To All Bidders of F-23-NQ-01:

Please note: the following addendum applies to F-23-NQ-01 and shall be taken into consideration when preparing bid documents.

Addendum #1
Upgrade of Neqotkuk Wastewater Treatment Facility
Project Number F-23-NQ-01

Drawing P04:

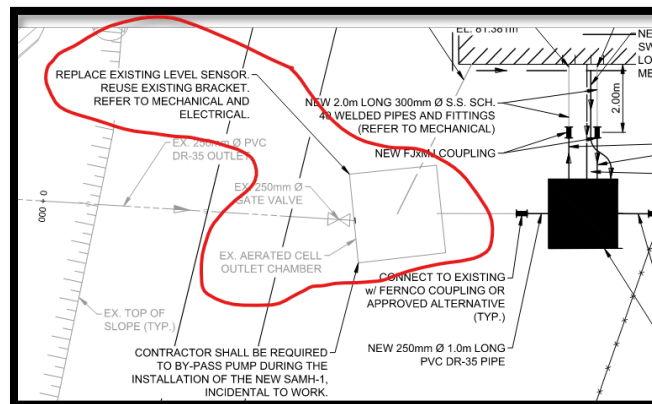
Question: Drawing P04 shows PIT-01 and FIT-01 on the common blower discharge header within the blower building however these transmitters are not shown on mechanical drawing M03. Please confirm location of these transmitters - supplied loose or within blower packages?

Answer: PIT-01 and FIT-01 are related to the air flow meter added to the scope of work as indicated on page 1 of this addendum.
